BHARAT HEAVY ELECTRICALS LIMITED
PROJECT ENGINEERING MANAGEMENT, NOIDA

CORRIGENDUM- 01

PROJECTs	:	KODERMA TPS PH-II (2x800 MW)
PACKAGE	:	WATER TREATMENT PACKAGES
ENQUIRY NO	:	77/25/6070/SAN Dated 07.07.2025
SUBJECT	:	TECHNICAL AMENDMENT + PRE-BID CLARIFICATIONS

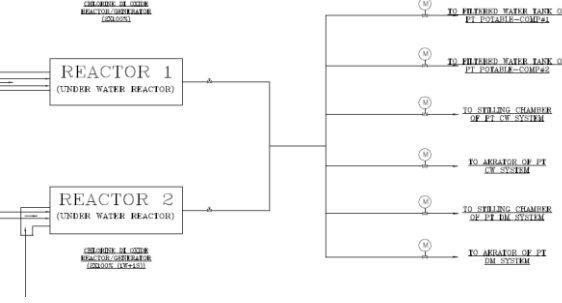
26.	Section-IA Annexure XII Drawing Plot plant	Location of decanted water sump of CHP WTP plant	Kindly provide the location of decanted water sump of CHP WTP plant in Plot plant.	Location of Decanted waster sump shall be near to CSSP Pond.

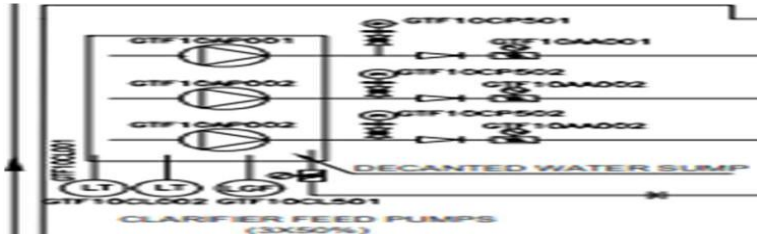
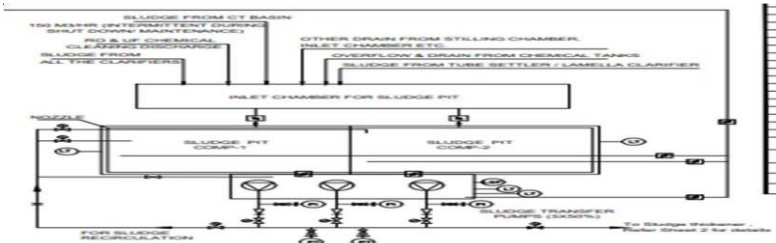
3		<p>Approved makes:</p> <p>RO pressure tubes /RO membrane housings</p>	<p>We are the only manufacturer for the recyclable RO Pressure tubes under the brand name KaiGO. Our RO Pressure tubes are being manufactured at our Ahmedabad Gujarat based factory.</p> <p>We have registered patent for this particular recyclable RO membrane tubes. We have manufactured more than 30 thousands numbers RO membrane tubes and supplied across the globe.</p> <p>Our RO pressure tubes have pressure ratings up-to 1800 psi and these pressure ratings are</p>	Bidder to refer cl. 13.7/Sub Section-IA/Section-I/Page 116 of 5195.
